REVIEW OF SAFETY ANALYSIS REPORT
FOR THE FFTF PIN SHIPPING CASK
MODEL T-3, REV. 3, JANUARY 25, 1980,
NUCLEAR PACKAGING, INC.

Z. Zudans

Figure 4. Simplified Differential Thermal Expansion Model

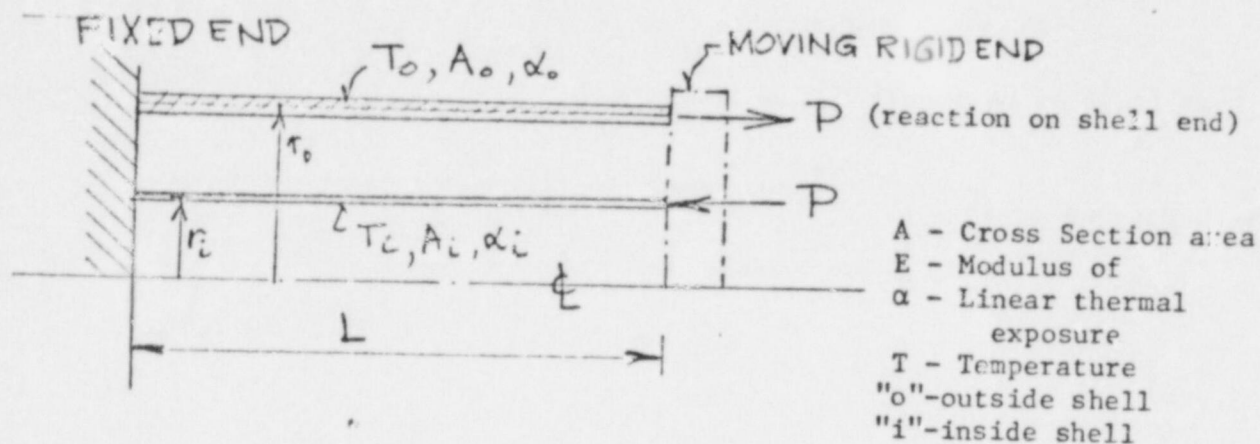
The simplified differential thermal expansion analysis (Pages 1-23 to 1-23a) assumes rigid ends moving axially. Lead is assumed to interact with these rigid ends, although due to differential thermal expansion there should be adequate clearance between the lead and the rigid ends. Because of that a better model for simplified analysis would be that shown in Figure 4. This model, however would also neglect interference between the lead and the inside shell. Differential expansion stresses for Figure 4 configuration are found from equating the axial displacements at the moving shell end.

This indicates that the values on Page 1-23a are conservative.

No analysis has been performed for thermal discontinuity stresses.

These stresses have not been added to pressure stresses (Page 1-119).

Figure 5. Rigid Body Motion

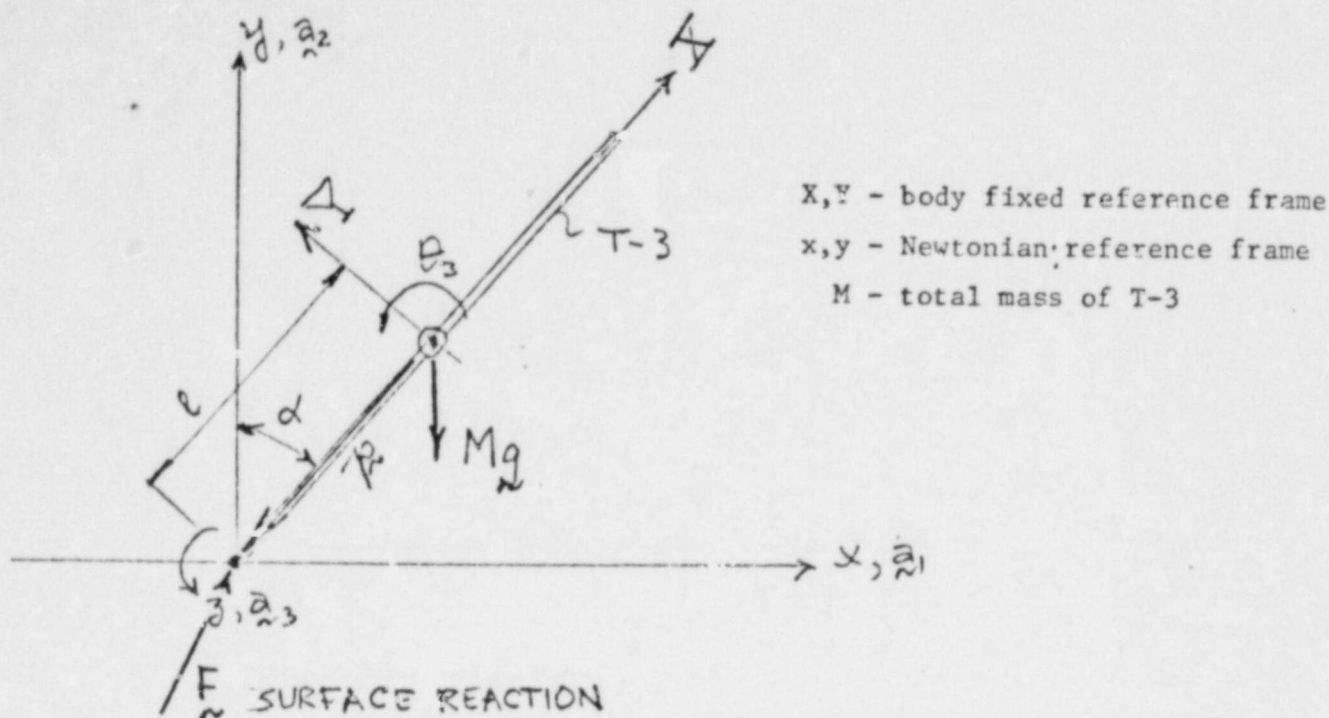
Free drop kinetic energy at the impact is correctly computed (Page 1-60). Corner drop internal force computation (Pages 1-60d to 1-60i) is incorrect: Equations of motion of the form given on Page 1-60e are only valid in a Newtonian reference frame (a reference frame at rest or at most at a uniform velocity). The local coordinates, X, Y, Page 1-60e, are tied to the body and are subject to acceleration, hence non-Newtonian coordinates.

Substitution of (2), (3) into (1) would introduce X, Y coordinates into equations, but the form would be quite different from that shown on Page 1-60e. Additional problems with Page 1-60e are: neglect of gravity force and assumption that \vec{F} will always be vertical (frictionless contact). Neglect of gravity force Mg may not be significant since the main contributor to stress will be the initial impact velocity.

It is noted further that the equations for the impact force calculation on Pages 1-60p to 1-60t are correct. The gravity load is included in these equations, but no horizontal reaction at the impact surface is considered. The assumption that \vec{F} will always go through T-3 corner is hard to justify. However, if Page 1-60 to 1-60i methodology is used for computation of internal forces, the results on Pages 1-60t to 1-60y are incorrect.*
